Re: Humboldt Bay Repowering Project (06-AFC-07):
Responses to CEC Staff Workshop Queries 3, 11, 14 and 15 and Data Requests 11, 55,
82 and 83

**Responses to CEC Staff Workshop Queries 3, 11, 14 and 15
and Data Requests 11, 55, 82 and 83**

Humboldt Bay Repowering Project

(06-AFC-7)

Figure 3. Survey Coverage.

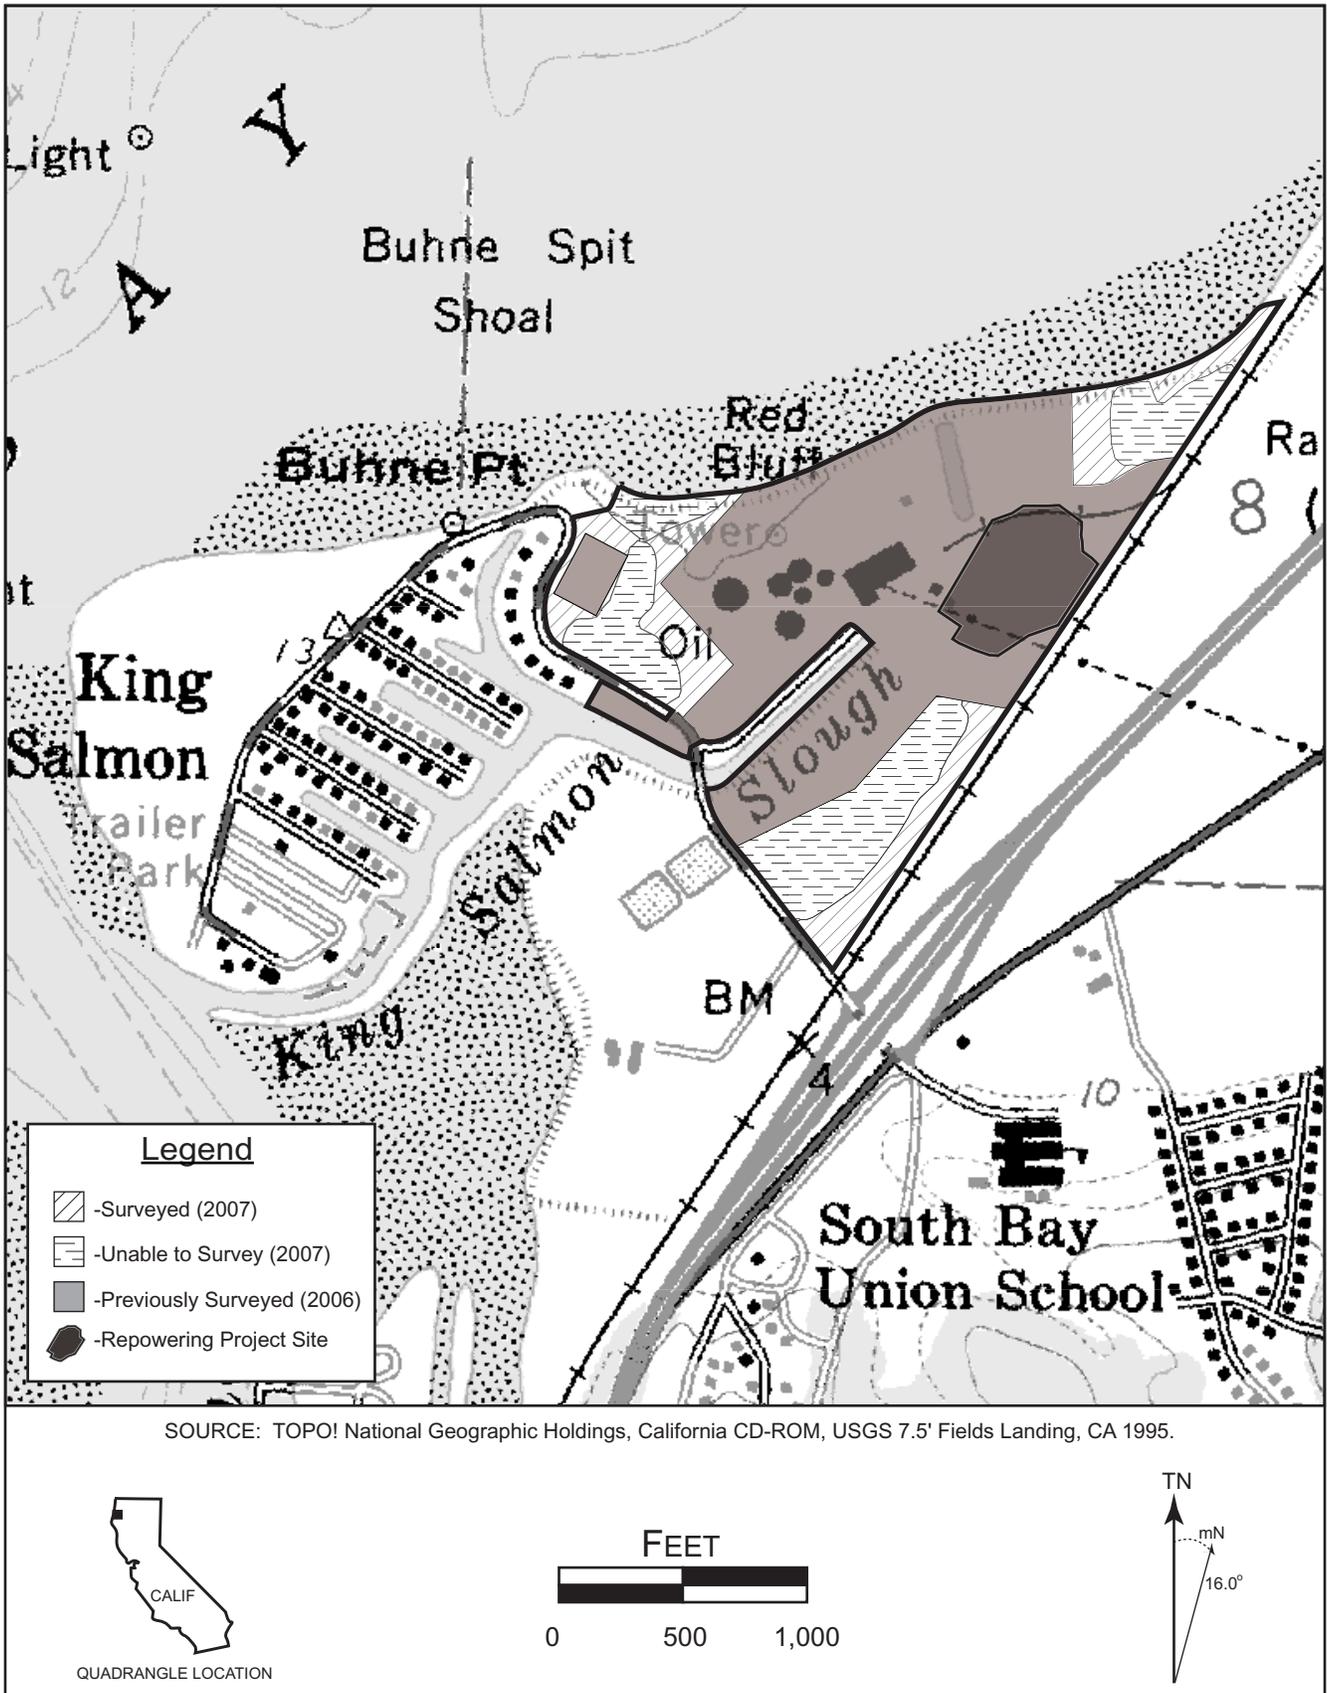
WSQ-11 *Please provide a cultural resources survey of the wetland mitigation land proposed for the HBRP.*

Response: PG&E has conducted a survey of all remaining portions of the PG&E parcel at Humboldt Bay Power Plant, including the lands proposed for wetland mitigation, and the report of this survey is included here as Attachment WSQ11-1. No cultural resources were identified within the mitigation area as a result of the survey.

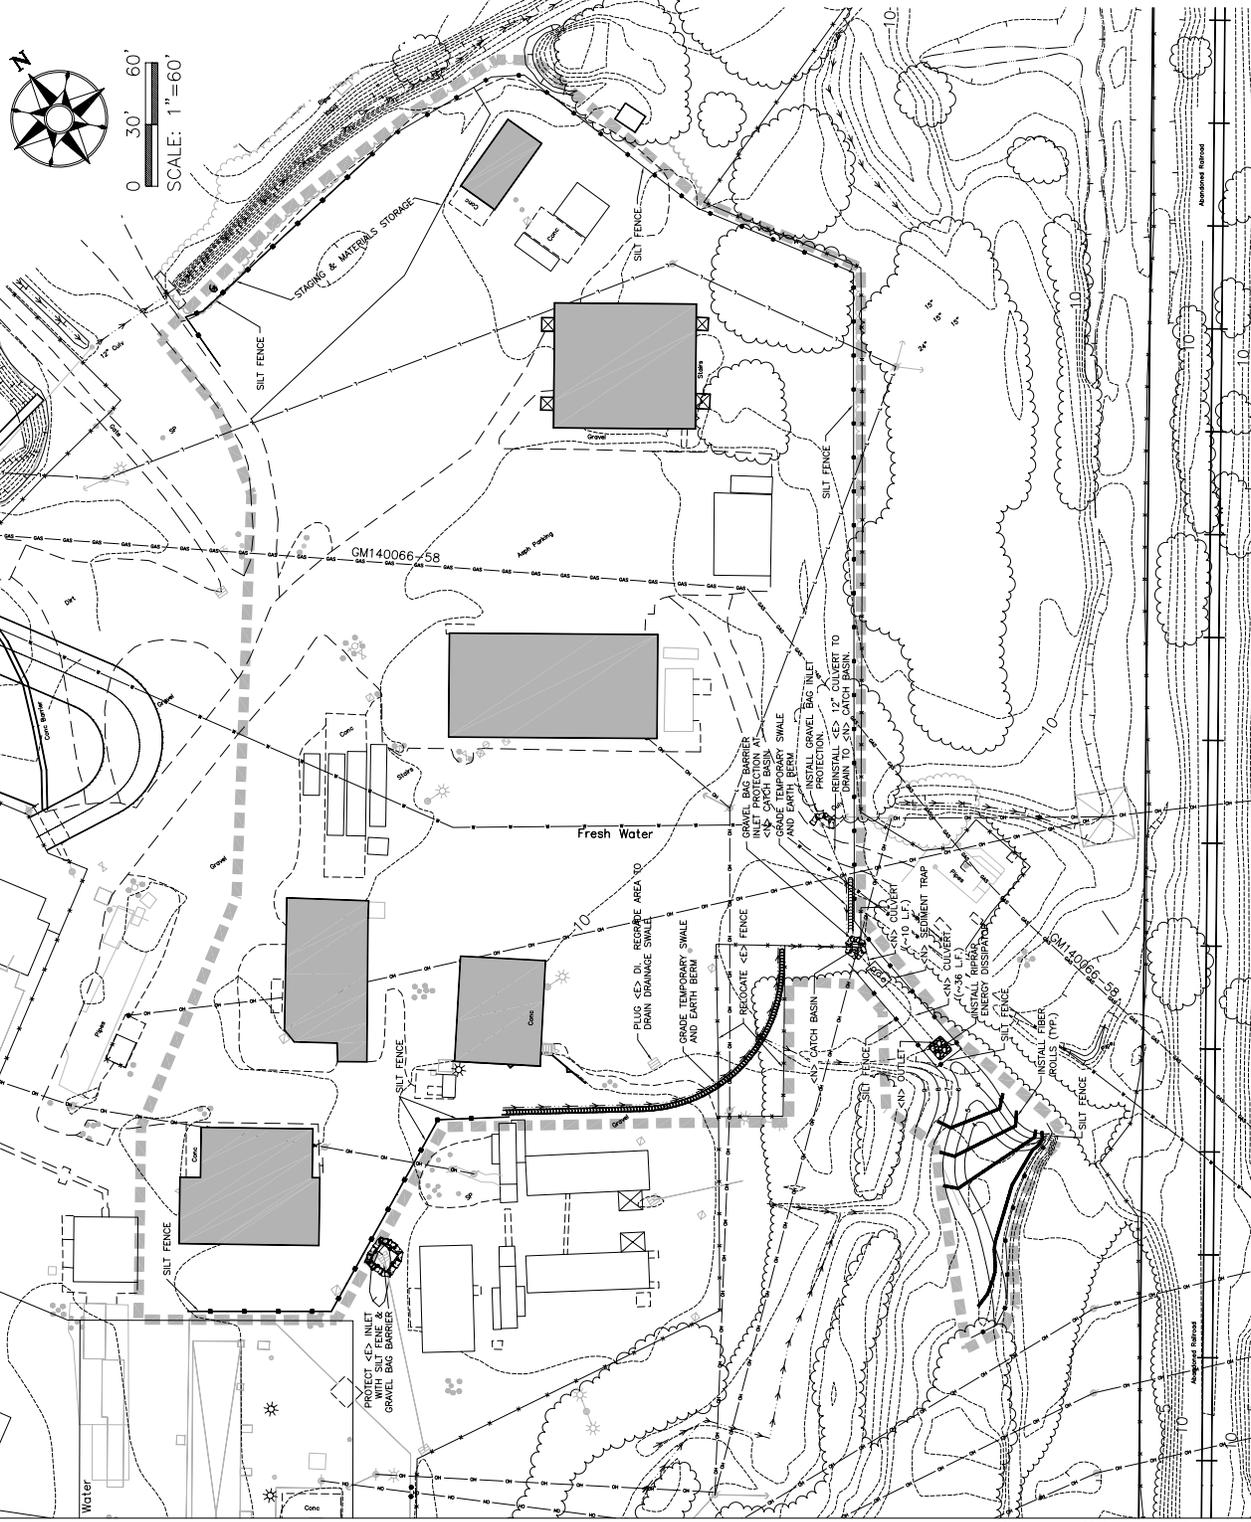
WSQ-14 *Please provide an update on the design of the discharge structure to convey stormwater to Buhne Slough.*

Response: The two figures included here as Attachment WSQ14-1 provide the conceptual design of the storm water outfall to Buhne Slough. Storm water generated from the Humboldt Bay Repowering Project will be routed to and collected in a new catch basin. The catch basin will be designed to accommodate a 50-year storm event. Flow will be directed from the catch basin through a new, 10-foot long, 24-inch diameter, culvert pipe to a new hydrodynamic separator. The hydrodynamic separator will retain suspended solids approximately 50 microns and larger in size, and be capable of storing up to approximately 1.8 cubic yards of sediment.

Flow from the hydrodynamic separator will be directed through a new approximately 36-foot long, 24-inch diameter, culvert pipe that will outlet to a new rip-rap energy dissipation feature. The rip-rap energy dissipation feature will be composed of Caltrans class 3 backing and lined with filter fabric.

Storm water will flow from the rip-rap energy dissipater to a new bioswale feature. The new bioswale feature will have side slopes no greater than 5 horizontal to 1 vertical and will be approximately 20 feet wide in the upstream portion, extending to approximately 100 feet wide in the downstream portion. Storm water will flow for approximately 90 feet through the new bioswale feature before entering the existing channel. Flow capacity of the existing channel has been assessed and is estimated to have adequate capacity to convey flow generated on the subject area resulting from a 100-year storm event. Storm water will flow for approximately 230 feet within the existing channel to Buhne Slough, which flows to Humboldt Bay.
